Access Compliance Report Public Rights-of-Way (Curb Ramps)

Main Street: WALKER_LEE_DR Cross Street: CHRISTY_LN Location: SE

ADA ID: RPRK211207132710 Ramp Type: Type 1 - Perpendicular Diagonal Initial Pass/Fail: Fail Overall Compliance: No Severity Score: 2

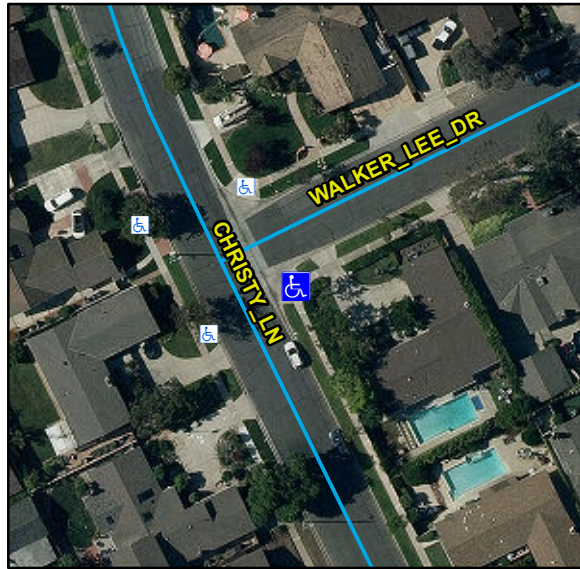
R204.3, R304.5.3, STD 1115

Remove & Replace Curb Ramp With Two New Directional Ramps or Equivalent.
